ADDENDUM NO. 3

Reference: **New Canada Road (PIN 107036.00)**
City of Lakeland
Shelby County, TN

The following additions, deletions, and/or revisions shall be made part of the Plans dated **August 30, 2024**, for the referenced project. This addendum shall have precedence over the plans and specifications on all items listed and described herein; however, it shall not change the intent and requirement of the plans and specifications for any item not specifically mentioned.

XC5

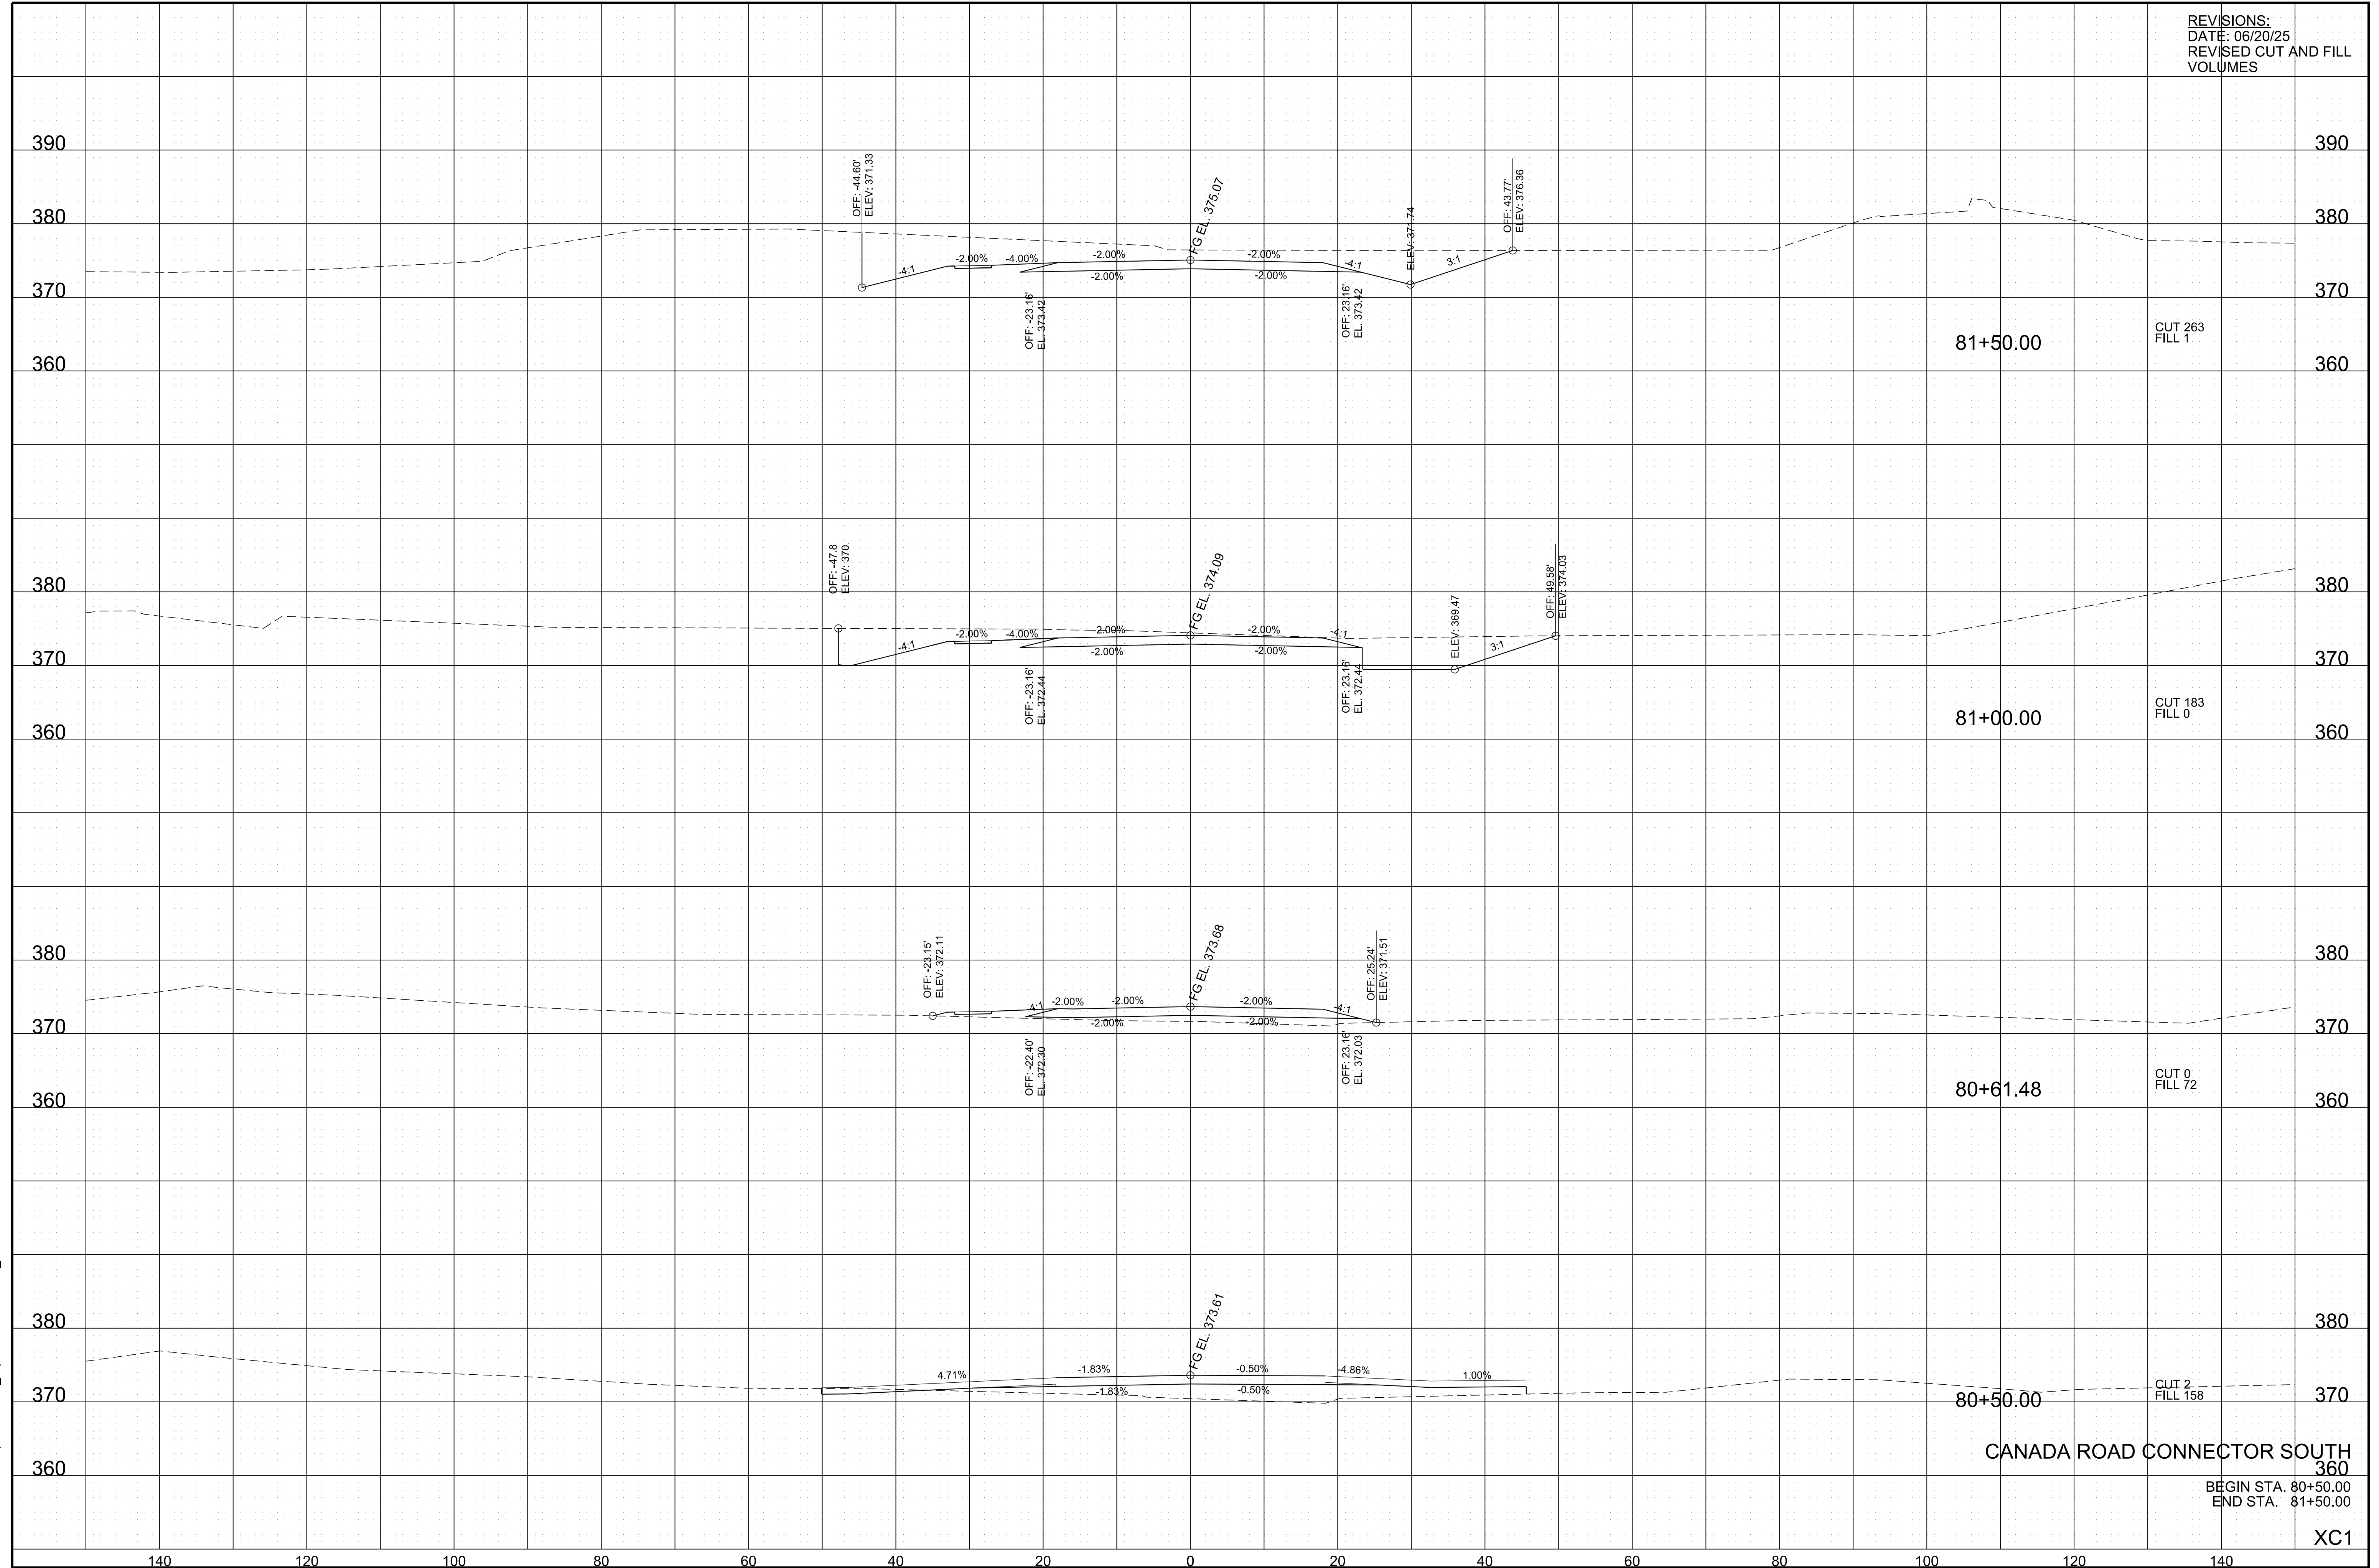
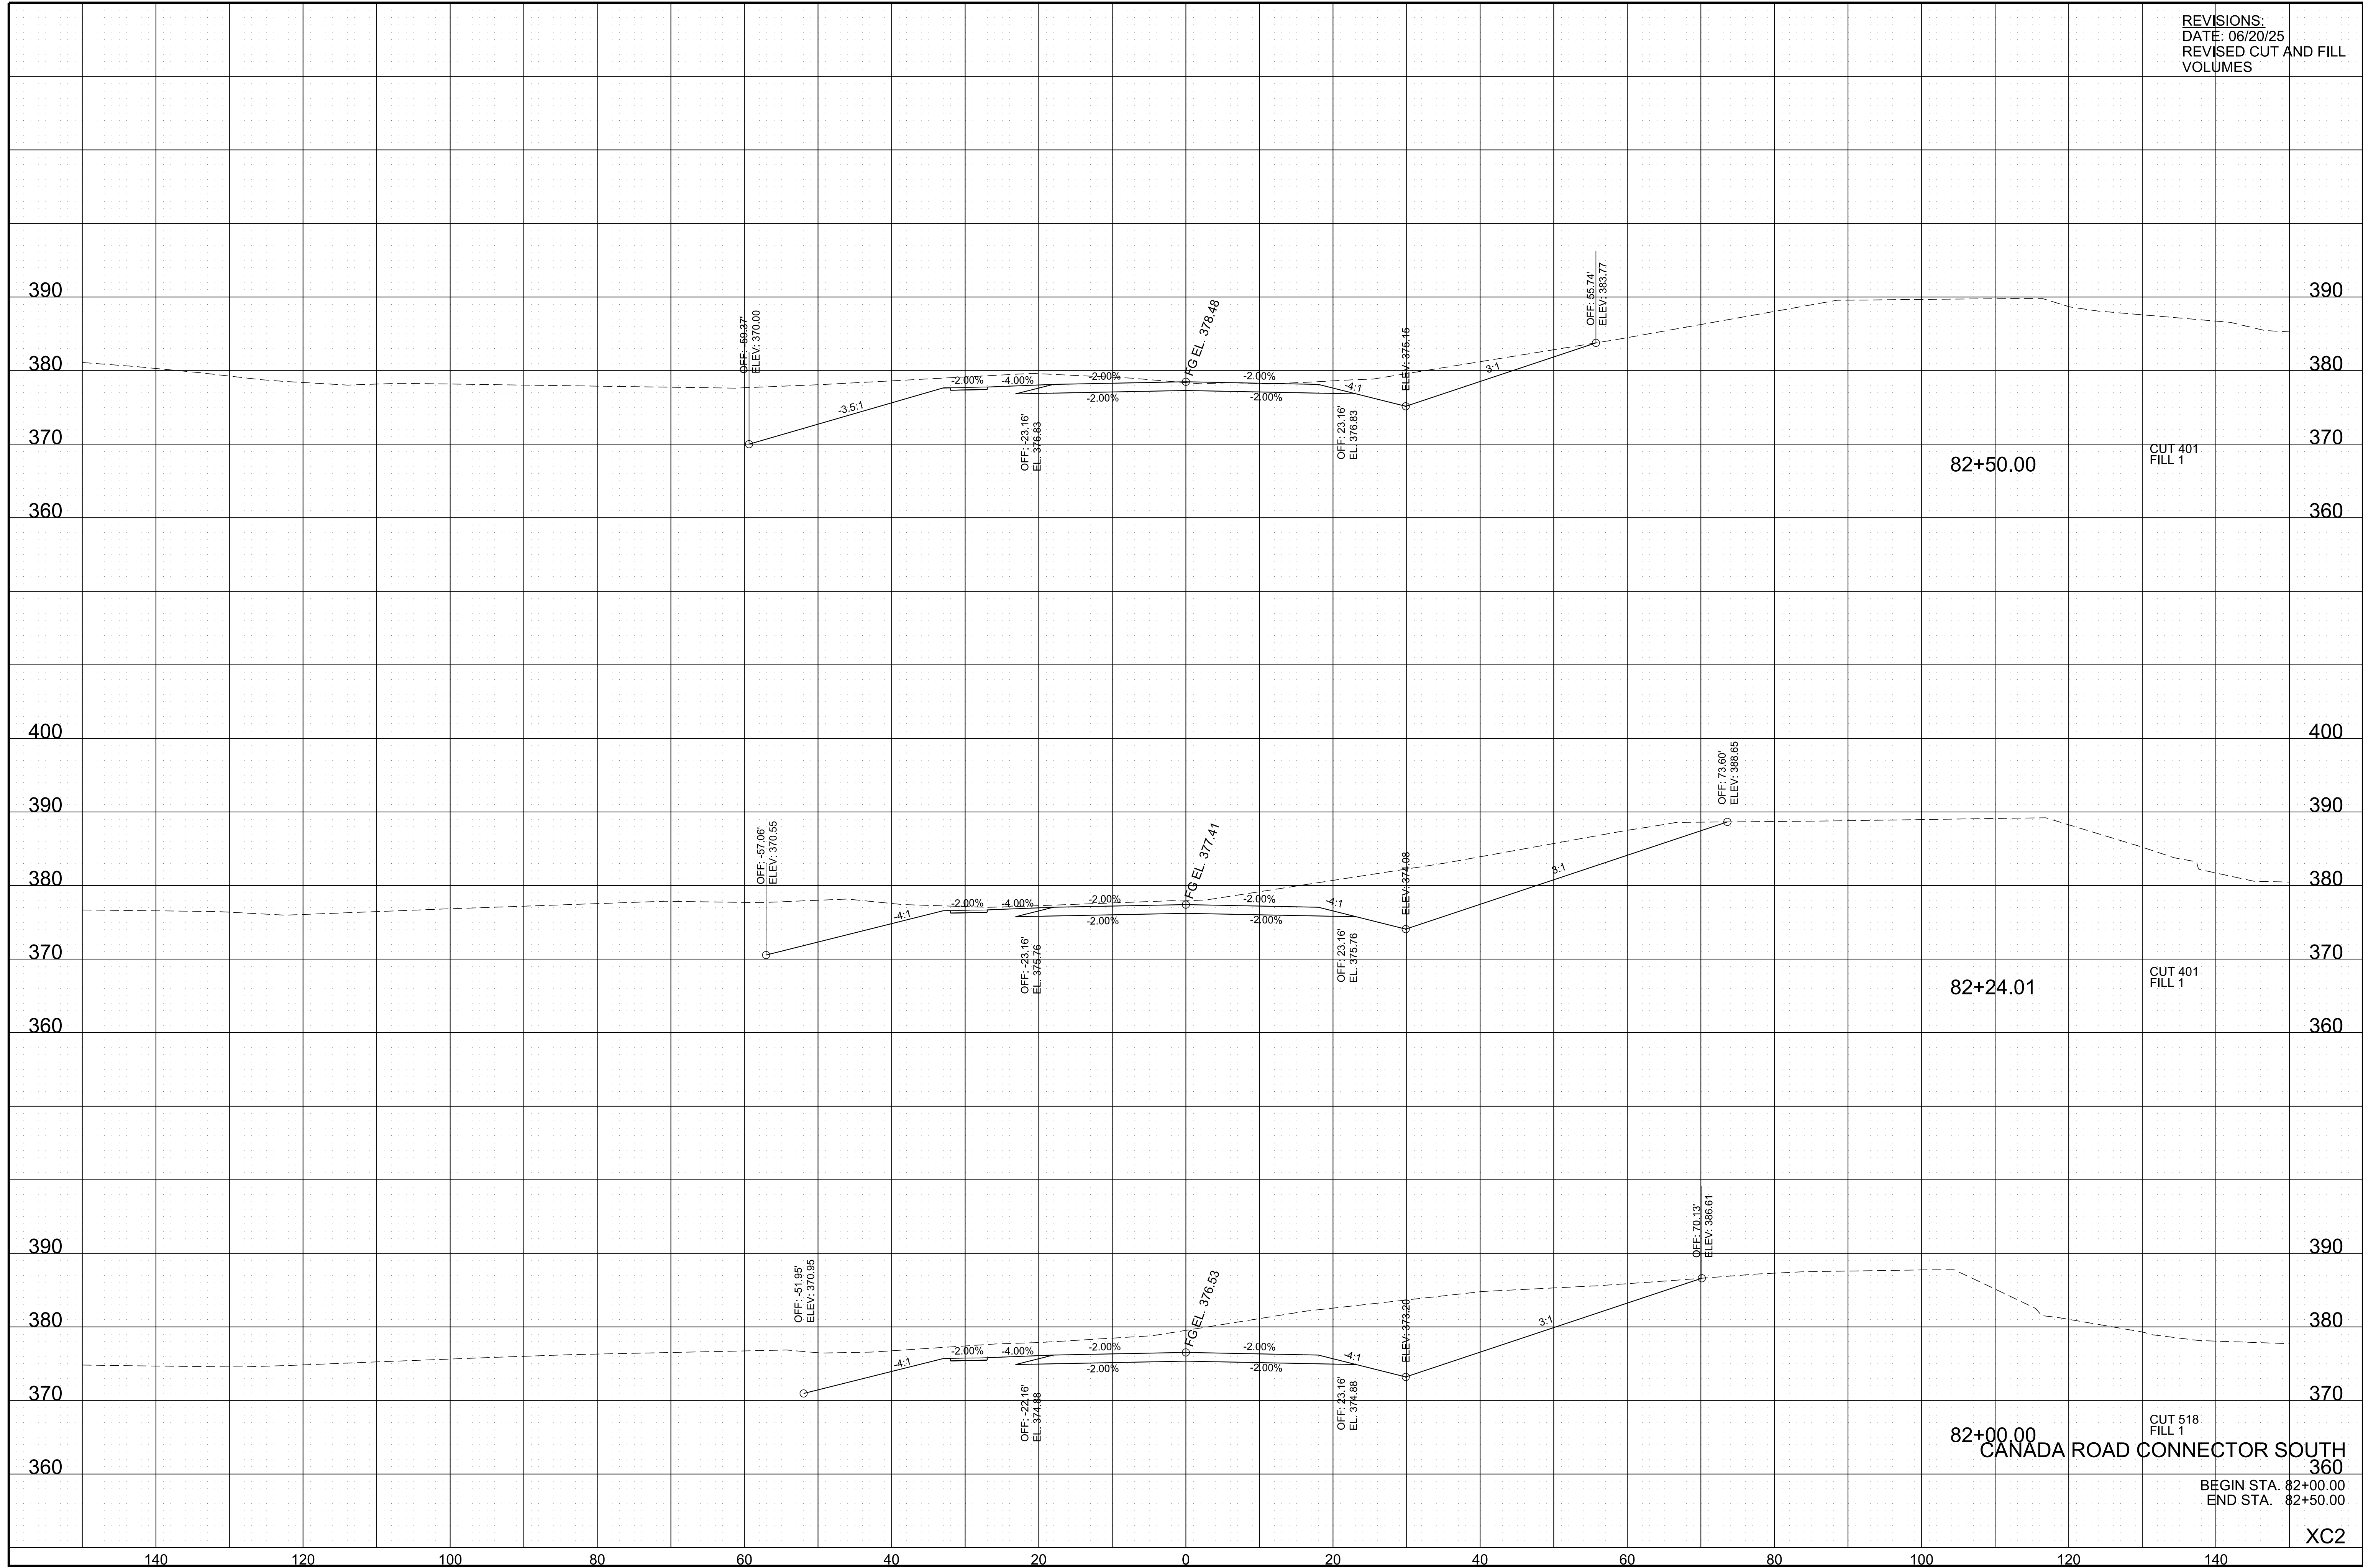
The following plan sheets have been revised and are included with this addendum: 2, 2-1, 2F7 and XC1 – XC5 (Canada Rd. Connector South cross sections).

REVISIONS:	
DATE: 06/20/25	
REVISED CUT AND FILL VOLUMES

REVISIONS:	
DATE: 06/20/25	
REVISED CUT AND FILL VOLUMES

REVISIONS:
DATE: 06/20/25
REVISED CUT AND FILL
VOLUMES
